GROWTH AND RESOURCE MANAGEMENT DEPARTMENT
PLANNING AND DEVELOPMENT SERVICES DIVISION
CURRENT PLANNING ACTIVITY
123 W. Indiana Avenue, Room 202, DeLand, FL 32720
(386) 736-5959

PUBLIC HEARING: July 12, 2016 - Planning and Land Development Regulation Commission (PLDRC)

CASE NO: V-16-057

SUBJECT: Variance to minimum yard requirements for a single-family dwelling on Urban Single-Family Residential (R-5) zoned property.

PLAT OF BOUNDARY SURVEY OF: LOT 3, HART SUBDIVISION, ACCORDING TO PLAT THEREOF AS RECORDED IN MAP BOOK 26, PAGE 22, OF THE PUBLIC RECORDS OF VOLUSIA COUNTY, FLORIDA.

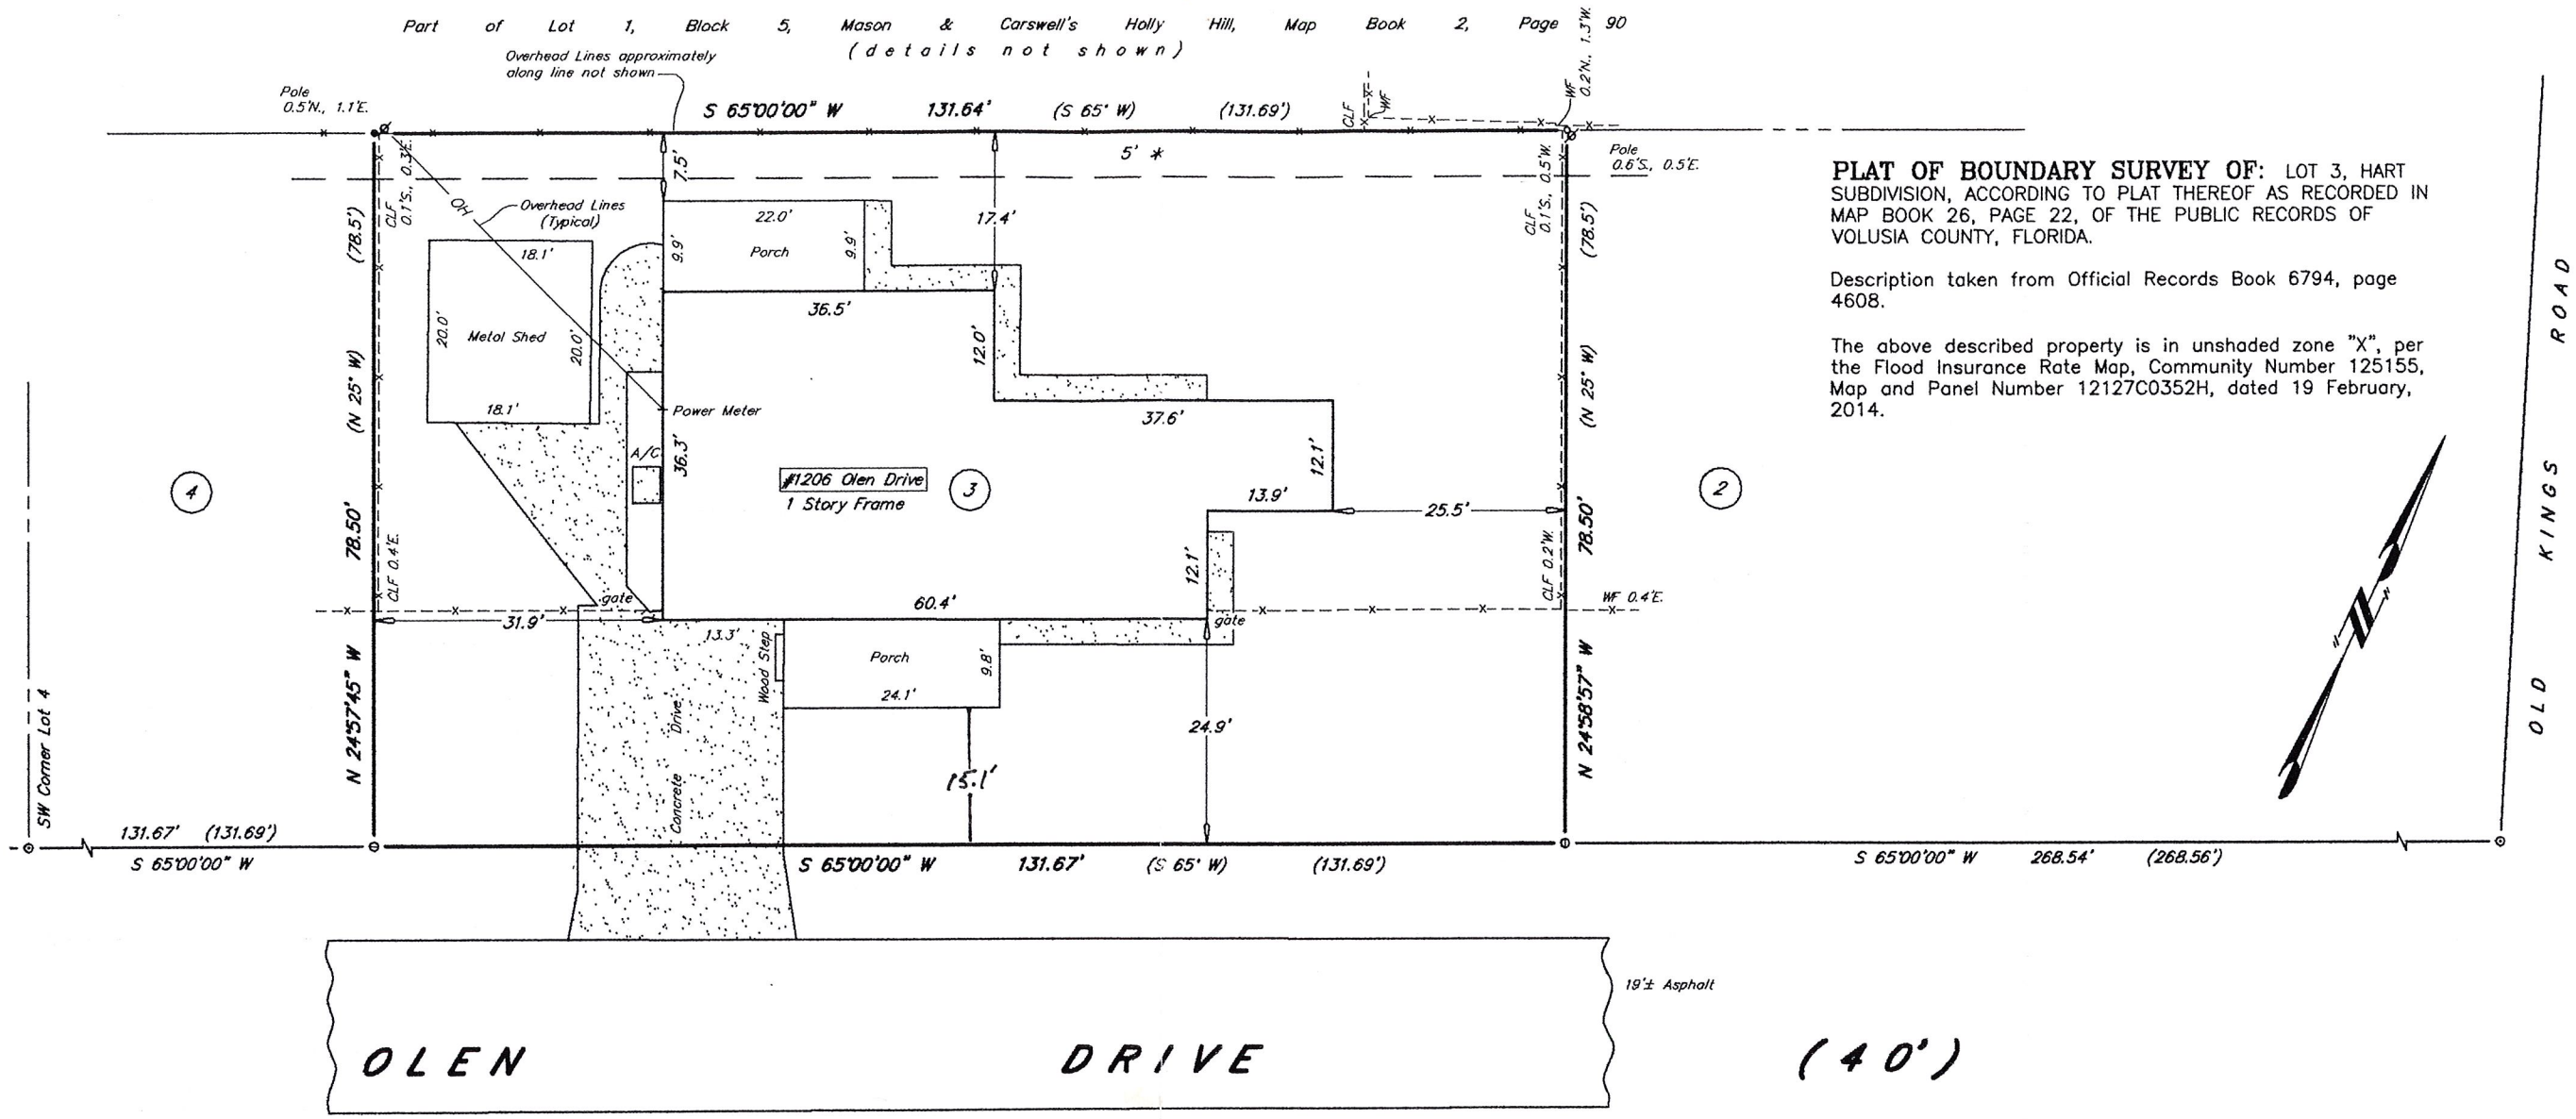
Per the submitted survey the front deck/porch does not meet the 25' front setback and the rear porch does not meet the rear 20' setback. A variance would be required to keep the deck porch in violation. Please contact Sara Payne at 736-5959 ext. 12735 to set up a meeting with one of the Current Planners to discuss the options of a variance.

VARIANCE SITE PLAN

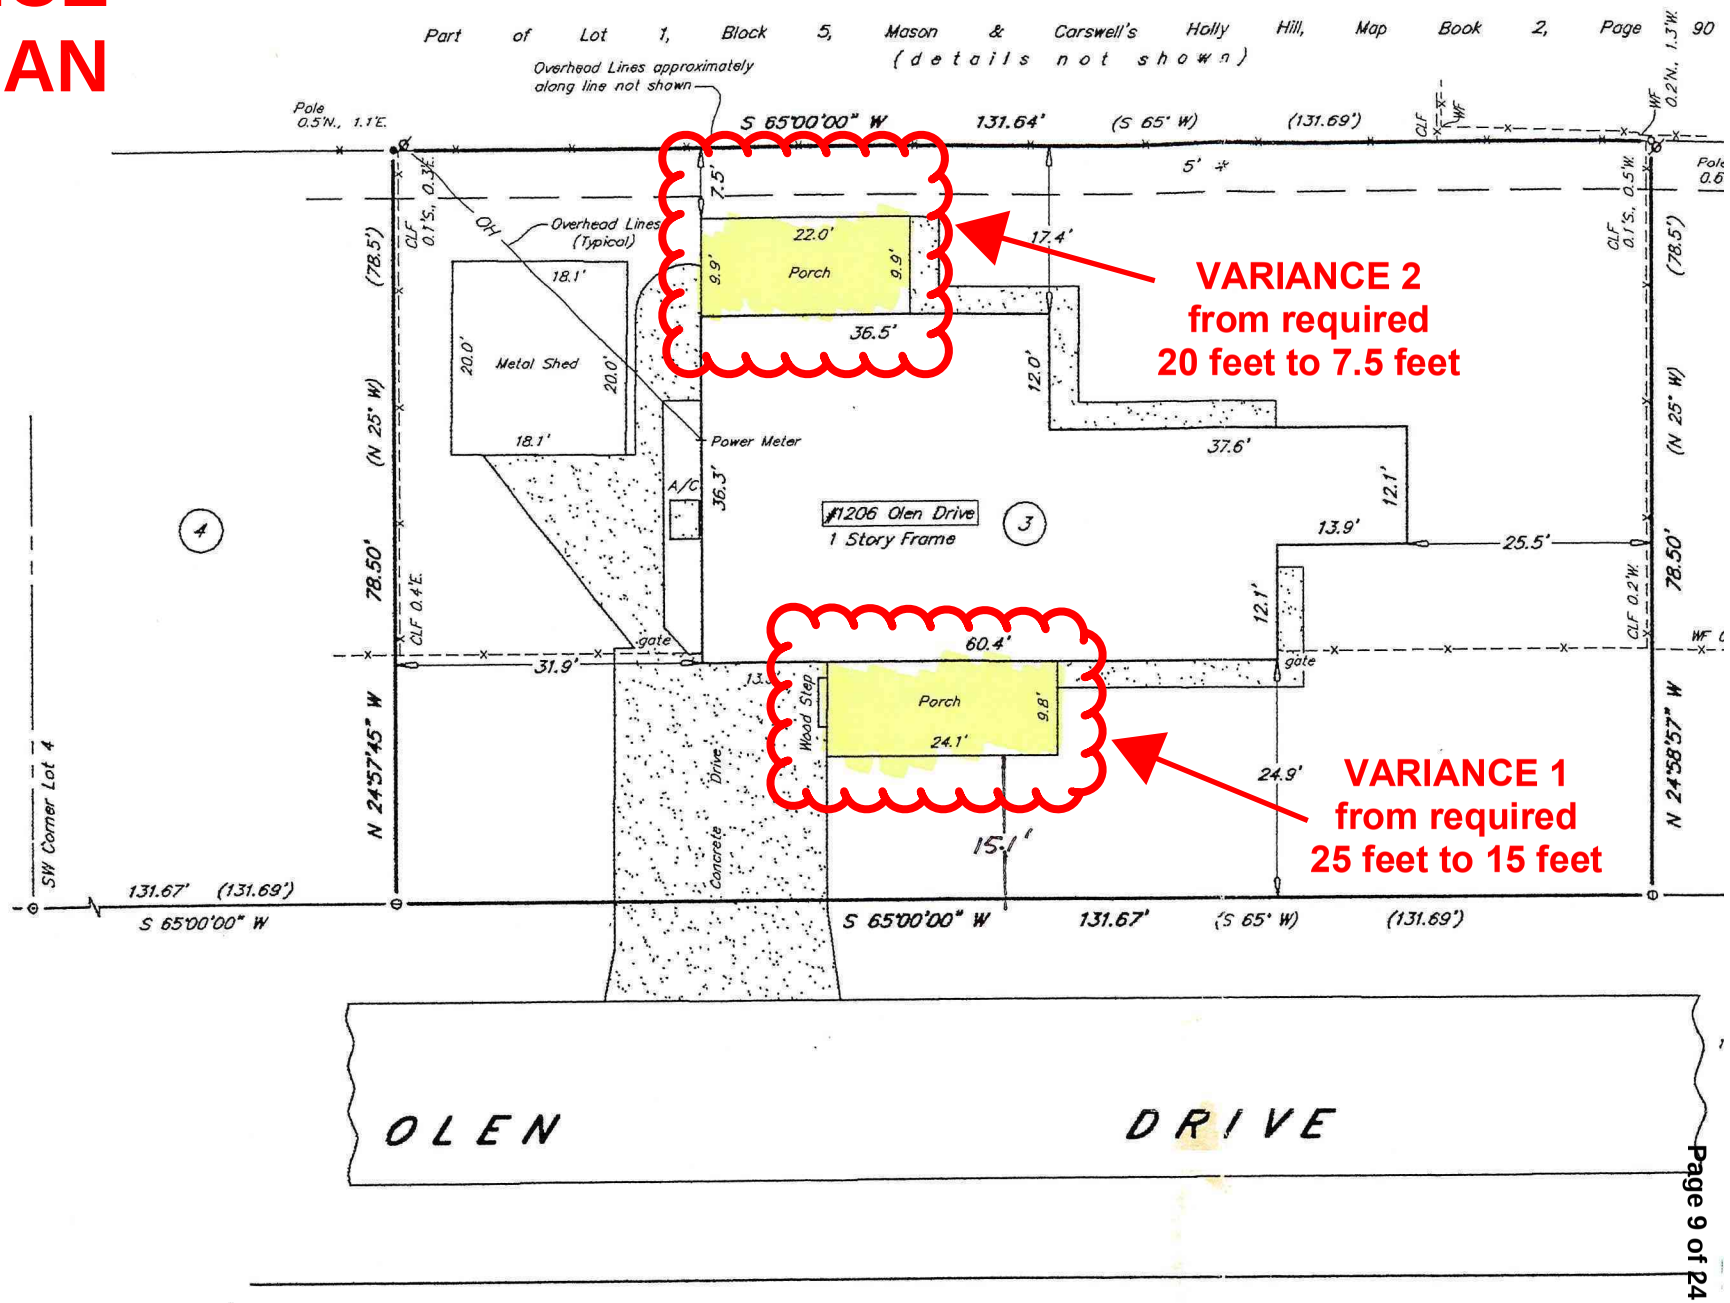
Variance 1: The existing front porch is a 24.1-foot wide by 9.8-foot long structure. The front yard requirement for the R-5 zoning classification is 25 feet. The front porch is located approximately 15 feet off the southerly front lot line. No permit or inspection was approved for this structure. The structure replaced a 20-foot wide by 4-foot long front porch that was constructed with the home in 1962, thus increasing the nonconformity.

Variance 2: The existing metal rear porch is a 22-foot wide by 9.9-foot long structure. The rear yard requirement is 20 feet whereas this structure is located 7.5 feet from the northerly rear lot line. This porch was constructed without a permit prior to the applicant's purchase of the property.

1. The variance is limited to a front porch with a front yard adjacent to Olen Drive of 15 feet and a rear porch with a rear yard of 7.5 feet, as depicted on the variance site plan/survey prepared by J.J. Matejka & Associates, Inc., dated April 14, 2014. The accessory structures subject to this variance application shall not be enlarged, increased, or extended further to encroach or occupy any greater area of the property without approval of a separate variance.

2010 BUILDING SKETCH

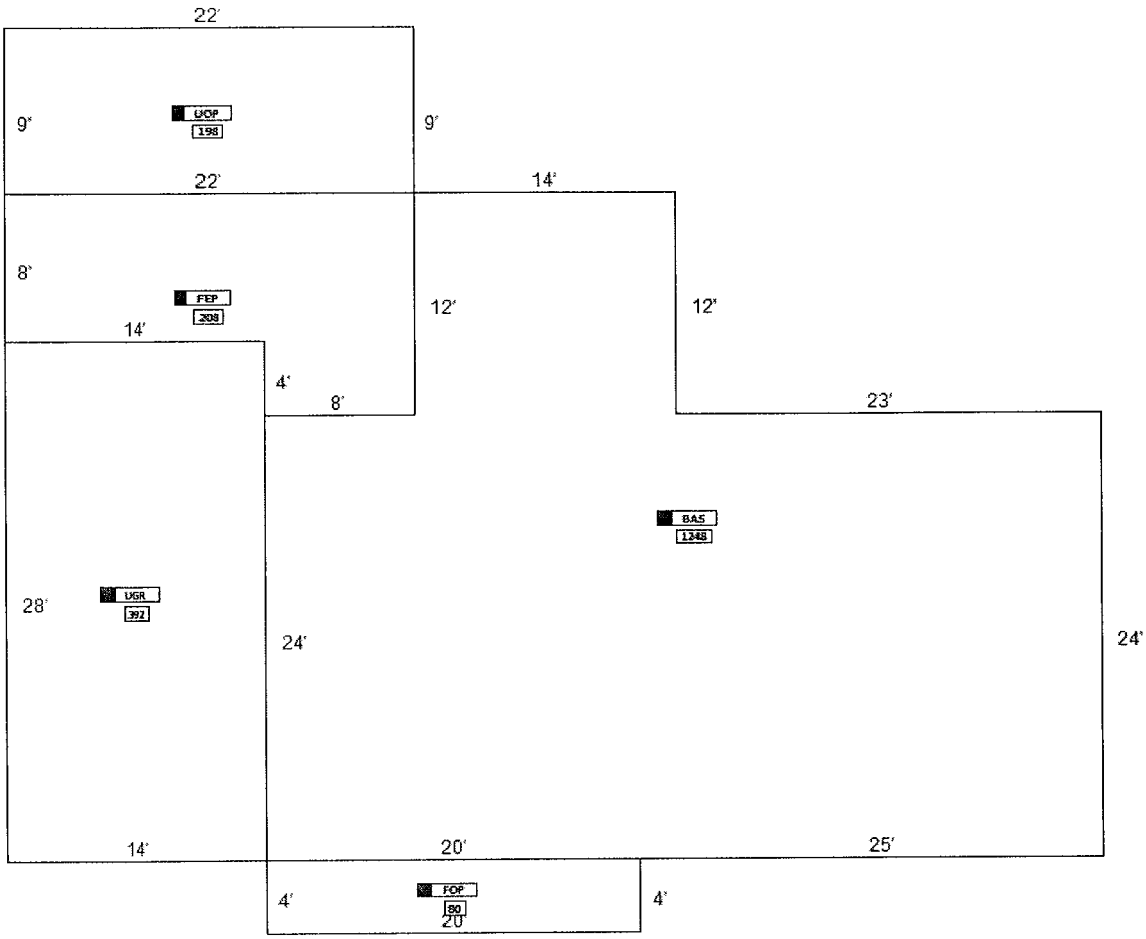
The original single-family dwelling was constructed in 1962. Per the applicant's survey, the existing home has nonconforming setbacks, with a 24.9-foot front yard setback and a 17.4-foot rear yard setback. A 4-foot by 20-foot front porch, as shown on the 2010 property appraiser building sketch, was constructed with the single-family dwelling in 1962. A 9-foot by 22-foot rear porch was constructed without a permit in 1990 within the required rear yard setback prior to the applicant's purchase of the property. The front porch was torn down and a new, larger 10-foot by 24-foot front porch was constructed without a permit within the required front yard setback. Both of the porches increase the nonconformity of the existing home.
